Office Action Summary

10/789,597

DETAILED ACTION

Bayles, Figure 2

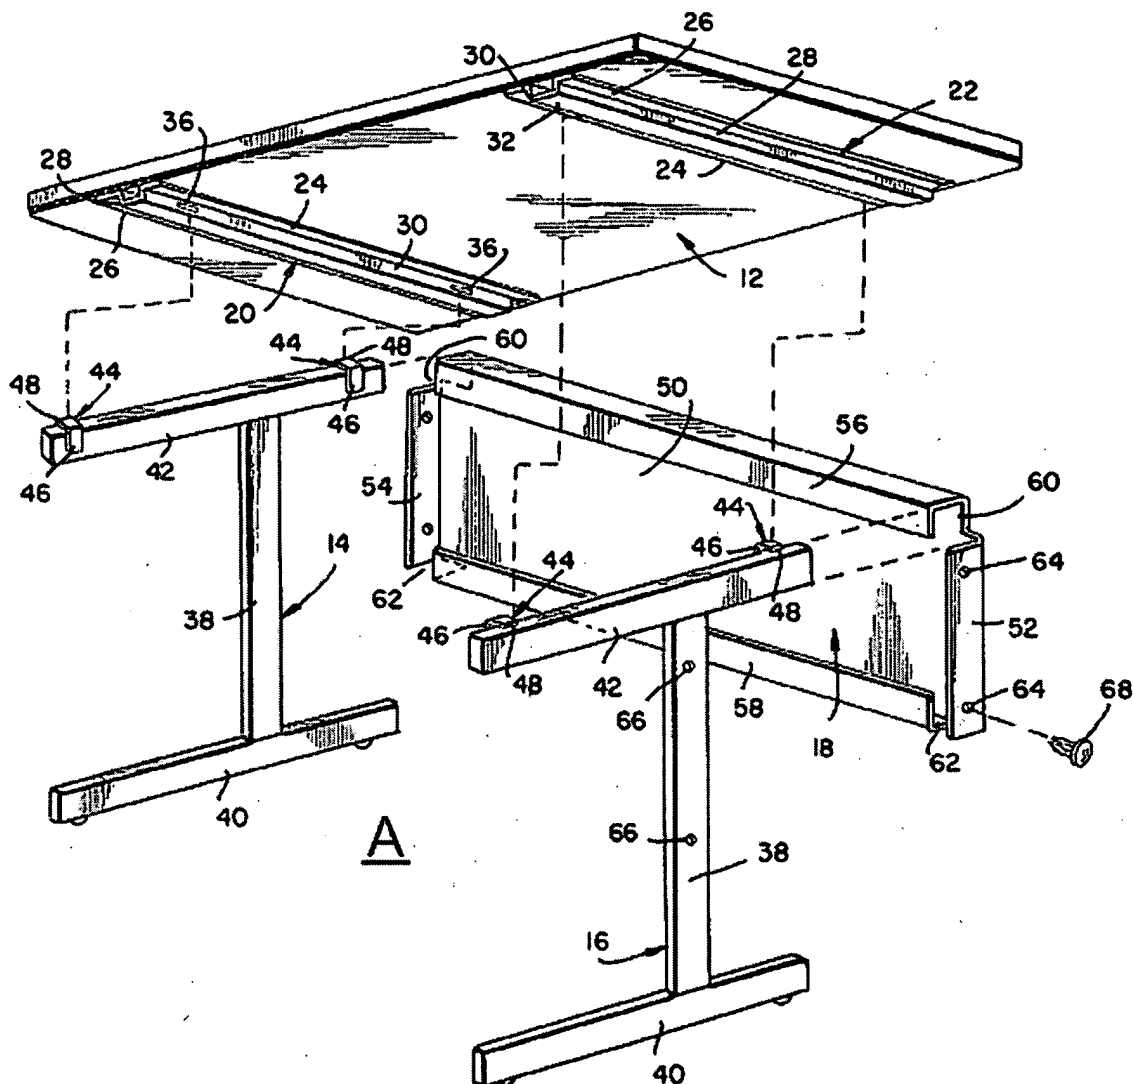
a. Regarding Claim 1, Bayles teaches a privacy screen (18) for use within a desk assembly having a worksurface (12) and an open span (A, best seen in Bayles, Figure 2) located below the worksurface comprising a first member (18) having a generally planar first portion (best seen in Bayles, Figure 2), a first flange (58) extending longitudinally along the first planar portion, and a first end

(52) and a second end (54) adapted to be secured to a desk assembly within an open span (A) located below a worksurface (12) of the desk assembly. Bayles does not teach a telescopically adjusting second portion of the privacy screen. Diamond et al. teach a panel having two members (20, 22), the first member (22) having a generally planar first portion (best seen in Diamond et al., Figure 1), a first flange (36) extending longitudinally along the first planar portion and a second member (20) having a generally planar second portion (best seen in Diamond et al., Figure 1), a second flange (32) extending longitudinally along the second planar portion and configured to telescopically receive the first flange of the first member therein such that planar second portion is substantially proximate the planar first portion thereby allowing adjustment of an overall length of the panel extending between the first end and the second end. It would have been obvious to one of ordinary skill in the art at the time of invention to modify the device of Bayles by using a telescopically adjusting panel as taught by Diamond et al. in order to allow the user to mount the panel on a diverse selection of desks with different span sizes.

- b. Regarding Claim 2, Bayles further teaches that the first flange (58) is substantially C-shaped (best seen in Bayles, Figure 2).
- c. Regarding Claim 3, Diamond et al. further teach that the first flange (36) includes a first portion (B) extending from and substantially orthogonal to the first

l. Regarding Claim 12, Bayles teaches a desk assembly, comprising a worksurface (12), a first supporting member (14) supporting the worksurface, a second supporting member (16) supporting the worksurface, wherein the first supporting member and the second supporting member cooperate to define a span (A) therebetween and a privacy screen assembly, comprising a first member (18) having a generally planar first portion (best seen in Bayles, Figure 2), a first flange (58) extending longitudinally along the planar first portion, a first

end (52) adapted to be secured to the first supporting member and a second end (54) secured to the second supporting member (best seen in Bayles, Figure 1). Bayles does not teach a telescopically adjusting second portion of the privacy screen. Diamond et al. teach a panel having two members (20, 22), the first member (22) having a generally planar first portion (best seen in Diamond et al., Figure 1), a first flange (36) extending longitudinally along the first planar portion and a second member (20) having a generally planar second portion (best seen in Diamond et al., Figure 1), a second flange (32) extending longitudinally along the second planar portion and telescopically received within the first flange (best seen in Diamond et al., Figure 2) such that planar second portion is substantially proximate the planar first portion such that the first member and second member are telescopically adjusted with respect to one another to extend across an entire length of a span. It would have been obvious to one of ordinary skill in the art at the time of invention to modify the device of Bayles by using a telescopically adjusting panel as taught by Diamond et al. in order to allow the user to mount the panel on a diverse selection of desks with different span sizes.

Diamond, et al., Figure 2

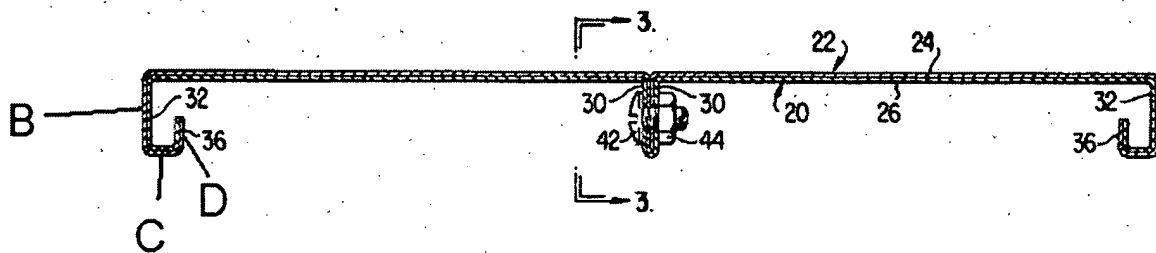
planar portion, a second portion (C) extending from and substantially orthogonal to the first portion, and a lip portion (D) extending from the second portion and towards the first planar portion. It would have been obvious to one of ordinary skill in the art at the time of invention to modify the device of Bayles by using a flange with three portions as taught by Diamond et al. in order to allow the panel to be folded into shape.

d. Regarding Claim 4, Diamond et al. further teach that the second flange (32) is substantially C- shaped (best seen in Diamond et al., Figure 2). It would have been obvious to one of ordinary skill in the art at the time of invention to modify the device of Bayles by using a C-shaped second flange as taught by Diamond et al. in order to more securely fit into the receiving portion of the first flange.

m. Regarding Claim 13, Diamond et al. further teach that the first flange (36) of the first member (22) is substantially C-shaped (best seen in Diamond et al., Figure 2). It would have been obvious to one of ordinary skill in the art at the time of invention to modify the device of Bayles by using a C-shaped first flange as taught by Diamond et al. in order to more securely connect the two panel members.

n. Regarding Claim 14, Diamond et al. further teach that the first flange (36) of the first member (22) includes a first portion (B) extending from and substantially orthogonal to the first planar portion, a second portion (C) extending from and substantially orthogonal to the first portion, and a lip portion (D) extending from the second portion and towards the first planar portion. It would have been obvious to one of ordinary skill in the art at the time of invention to modify the device of Bayles by using a flange with three portions as taught by Diamond et al. in order to allow the panel to be folded into shape.

o. Regarding Claim 15, Diamond et al. further teach that the second flange (32) is substantially C- shaped (best seen in Diamond et al., Figure 2). It would have been obvious to one of ordinary skill in the art at the time of invention to modify the device of Bayles by using a C-shaped second flange as taught by Diamond et al. in order to more securely fit into the receiving portion of the first flange.

Diamond et al., Figure 2 (Detail)

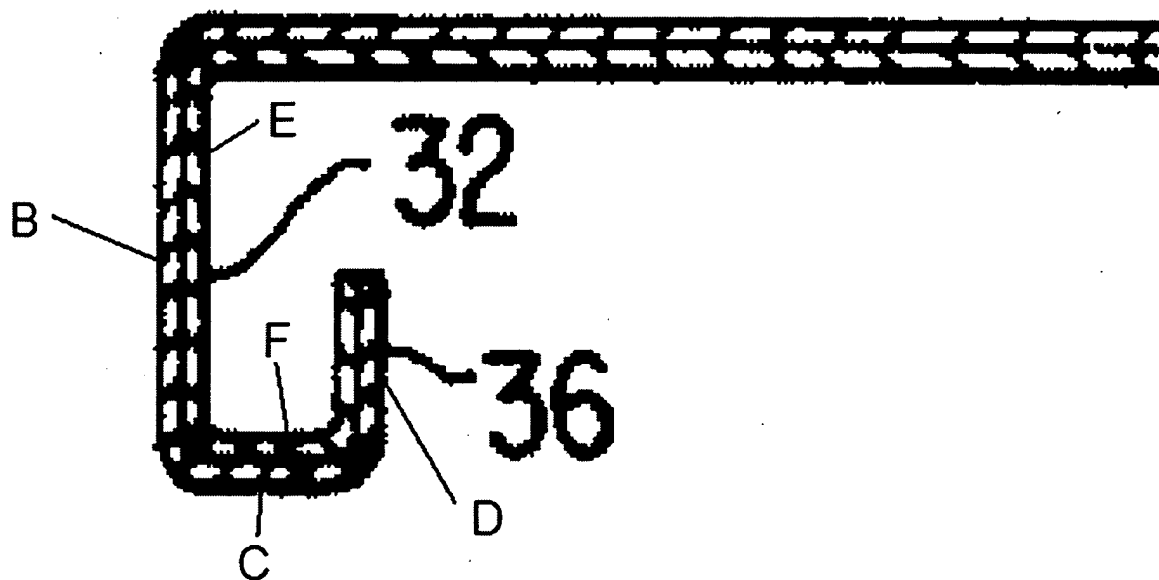
e. Regarding Claim 5, Diamond et al. further teach that the second flange (32) includes a first portion (E, best seen in Diamond et al., Figure 2 Detail, below) extending from and substantially orthogonal to the second planar portion and a second portion (F) extending from and substantially orthogonal to the second portion of the second flange, and wherein the second portion (F) of the second flange is telescopingly received between the second portion (C) of the first flange and the lip portion (D) of the first flange (Note: the second portion of the second flange is considered received by the first flange as it resides in the space defined by the second portion and the lip portion). It would have been obvious to one of ordinary skill in the art at the time of invention to modify the device of Bayles by using a two-portion second flange as taught by Diamond et al. in order to allow the panel to be folded into shape.

p. Regarding Claim 16, Diamond et al. further teach that the second flange (32) of the second member (20) includes a first portion (E, best seen in Diamond et al., Figure 2 Detail, above) extending from and substantially orthogonal to the second planar portion and a second portion (F) extending from and substantially orthogonal to the second portion of the second flange, and wherein the second portion (F) of the second flange is telescopingly received between the second portion (C) of the first flange and the lip portion (D) of the first flange (Note: the second portion of the second flange is considered received by the first flange as

it resides in the space defined by the second portion and the lip portion). It would have been obvious to one of ordinary skill in the art at the time of invention to modify the device of Bayles by using a two-portion second flange as taught by Diamond et al. in order to allow the panel to be folded into shape.
